CMD 23-M36.5

**Written submission from  
Paul Sedran, RESD Inc.**

Regulatory Oversight Report for  
Canadian Nuclear Power Generating  
Sites: 2022 and Mid-term update for  
Ontario Power Generation's Pickering  
Nuclear Generating Station

Review of Submissions for the Midterm Review of  
Licensed Activities for Pickering NGS

**Figure 1**  
**Example of the Calibration of the Axial Gap**  
**Profile for Fuel Channel G2 H114**

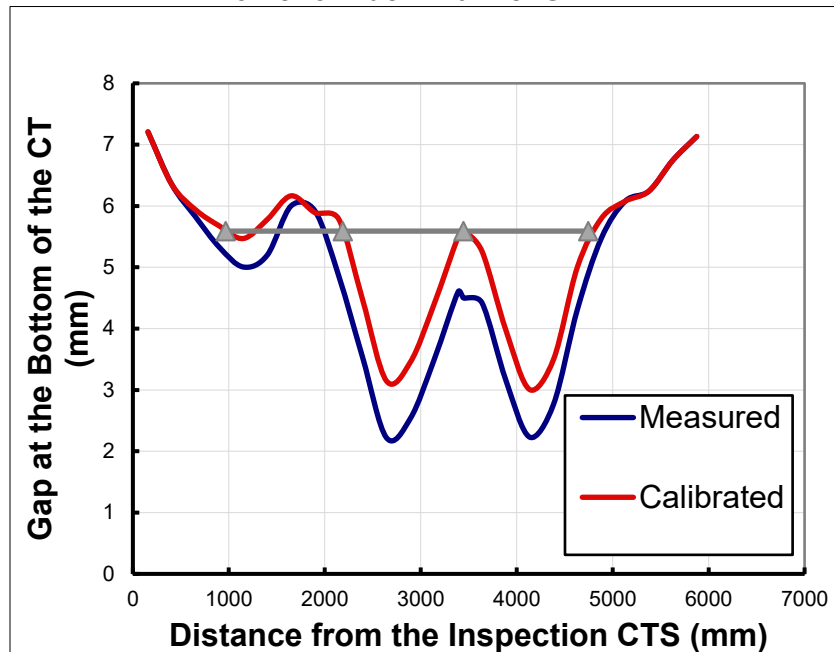
It is apparent from Figure 1 and 2 that gap calibration results in an increase in the magnitude of the gap for each point along the axial gap profile, except for the points at the beginning and end of the axial gap profile, where gap calibration has no effect on the gap. As an example, for the gap at 2640 mm from the CTS, calibration will raise the gap from 2.22 to 3.10 mm, for an increase of 0.88 mm. In most structural components, a deformation of less than 1 mm would have negligible mechanical consequences.

However, in this case, a 0.88 increase in gap at the 2640 mm axial location represents an increase of 39.6%, compared to the actual gap measurement at 2640 mm. For the Fuel Channel with the axial gap profiles depicted in Figure 1, an increase of 0.88 mm in the gap at 2460 mm will result in a significant increase in the predicted onset time for CT-PT contact.

Therefore, the gap calibration method depicted in Figure 1 has the following implication for CT-PT time-to-contact predictions. Since predicted CT-PT time-to-contact values, based on calibrated gaps, are greater than the corresponding time-to-contact predictions with no gap calibration, then gap calibration would result in overestimations of time-to-contact, compared to time-to-contact predictions with no gap calibration.

As a result, the gap calibration method in question could potentially have a negative effect on the level of conservatism present in CT-PT time-to-contact predictions and so it merits a considerable amount of scrutiny and technical justification.

**Figure 5**  
**CT ID Profiles from the 2004 Inspection of**  
**Fuel Channel PLGS F06 with Gap Calibration**

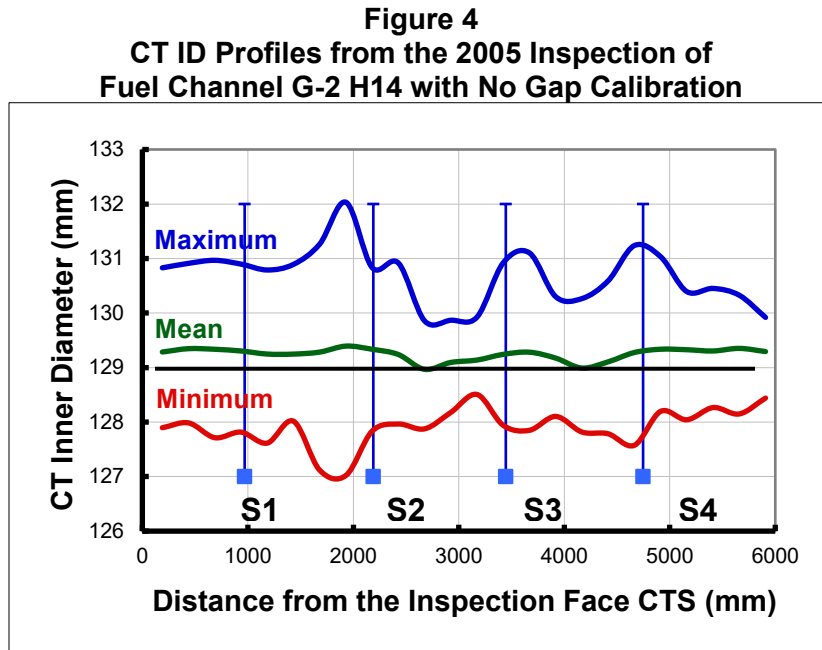
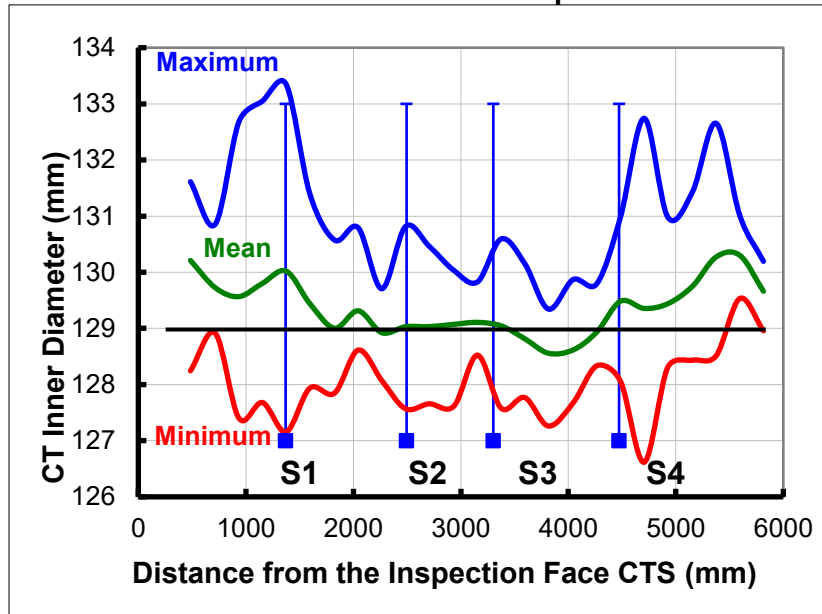
The critical point in comparing Figures 4 and 5 is that actual gap measurements were used in the generation of the CT ID profiles in Figure 4, whereas in Figure 5, calibrated gap measurements were used.

Examining Figure 4, it is seen that, with no gap calibration, the CT mean ID is somewhat uniform, with a range of 0.393 mm, over the length of the CT in G-2 H14.

In contrast, as shown in Figure 5, with gap calibration, the mean CT ID is almost uniform only between Spacers 2 and 3 but varies significantly of the length of the CT in PLGS F06. With gap calibration, 1.74 mm is the range in the mean CT ID.

The above comparison of Figure 4 with Figure 5 establishes that there is an actual difference in the mean CT ID profiles generated with and without gap calibration, which is expected, since the CT ID partially depends on the gap.

Therefore, it is proposed that the gap calibration scheme used to produce the CT ID profiles for PLGS F06 of Figure 5, assuming that no other unexplored factors are at play, resulted in an overestimation of various gap values, manifested in Figure 5 as an overestimation of the CT mean ID at different points along the CT.

If the above proposition is correct, the implication is that the gap calibration scheme in question is technically incorrect, since the calibrated gaps, when used to generate in-service CT ID profiles, result in unrealistic CT ID values, i.e. profiles that do not match those for P4 M11.

Therefore, in order for the Fuel Channel analysts to continue to use the gap calibration scheme for the PNGS Fuel Channels, there should be an investigation into the effect of the calibrated gaps on the resultant CT ID profiles. The investigation would be to determine if the irregular CT mean ID profiles of Figure 5 are attributable to gap calibration alone.

If so, then the recommendation would be that OPG discontinue the use of gap calibration in the interpretation of gap measurement results for the PNGS Fuel Channels. One possibility is that the measured gap values (without calibration) could be used in Fuel Channel fitness-for-service assessments for PNGS, instead of the calibrated gap values.

**Figure 6**  
**ID Profiles from the Ex-Service Gauging of the CT**  
**Removed from Fuel Channel M11 for LSF CR**

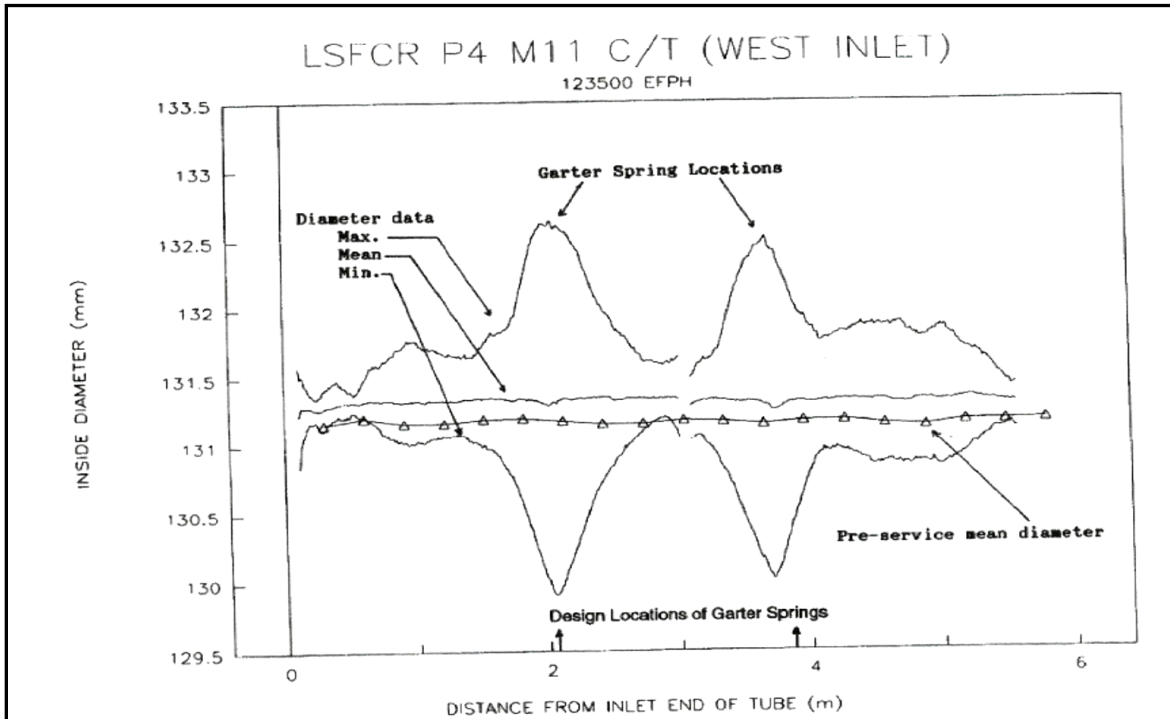
It is also observed in Figure 6 that the mean in-service CT ID is practically uniform over the length of the CT and closely matches the as-installed CT ID value at each point along the length of the CT to within 0.2 mm, noting that the in-service mean ID of the CT is slightly greater than the mean as-installed ID.

Looking at Figure 6, it is evident that CT M11 from Pickering Unit 4 displays circumferential bending deformation, leading to ovality at the spacers plus a small amount of circumferential expansion.

Comparing Figures 4 and 5 with Figure 6, it is seen that the mean in-service CT ID profile for P4M11 (Figure 6) is more consistent with the profile of Figure 4 than with the profile of Figure 5.

On the basis of the similarity between Figures 4 and 6 and the discussion of spacer loading, above, the conclusion is that the actual in-service deformation of the CT should feature a near-uniform mean ID profile, with a slight diametral expansion relative to the as-installed mean diameter of the CT, which was evident in P4 M11, in Figure 6.

**Figure 8**  
**Illustration of the PT Span Between S1 and S2**  
**for G2K07 at 161 kEFPH With No Gap Calibration**

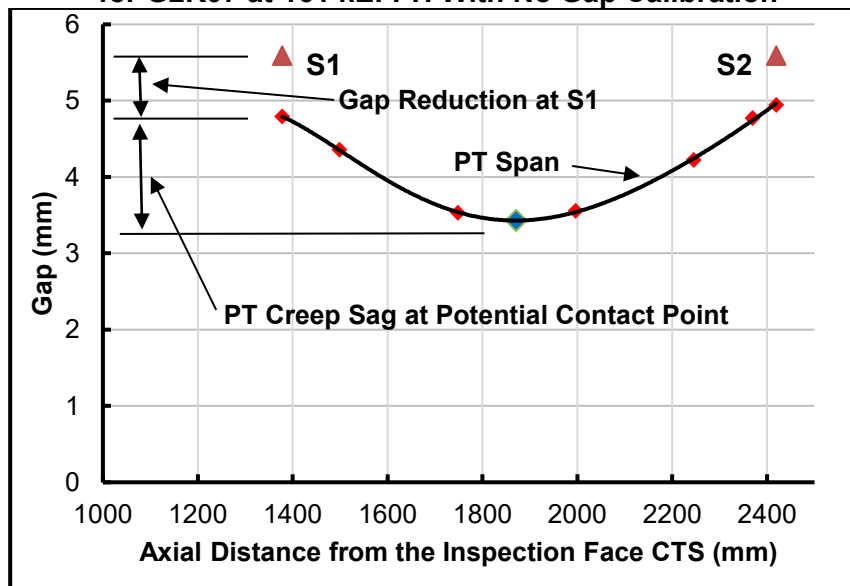
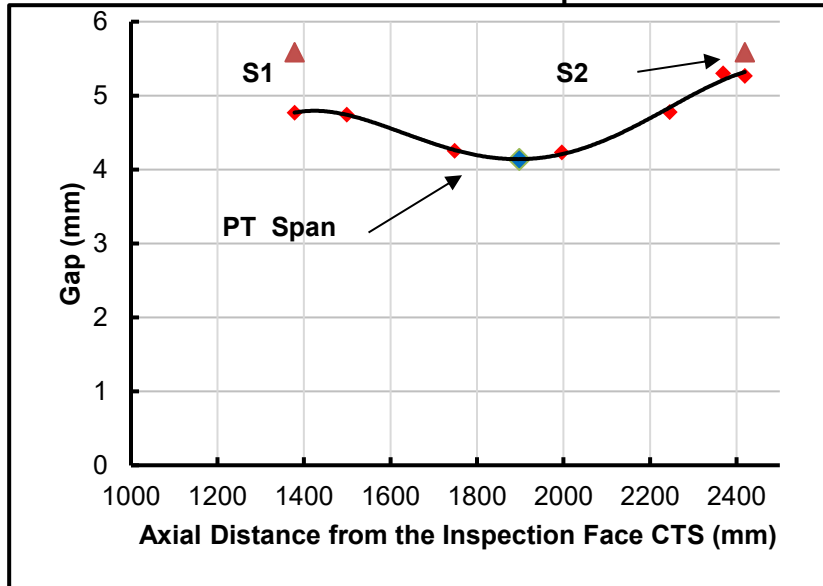
From Table 6, the measured and calibrated gaps are practically unaltered by the removal of the UDL during inspection and the weight of the inspection tool. It can be seen that gap calibration significantly increases the gap at the potential contact point at 161,000 EFPH but also assumes a lower rate of gap reduction at the spacer locations. These two combined effects result in a significantly greater time-to-contact prediction for the case of gap calibration versus that for the use of the as-measured (uncalibrated) gap profile.

In this particular example, the increase in time-to-contact from the use of gap calibration is immaterial to the integrity of the Fuel Channel, since both 417 and 622 kEFPH are well above the original Fuel Channel design life of 210 kEFPH. However, in this case gap calibration results in a 49% increase in time-to-contact compared to the time-to-contact using the as-measured gap profile.

Although it is possible that the time-to-contact predictions for the PNGS Fuel Channels could also be acceptable without gap calibration, gap calibration is less conservative than the use of as-measured gaps and may not be technically justifiable because of the implications of gap calibration for CT ID profiles, described in this report.
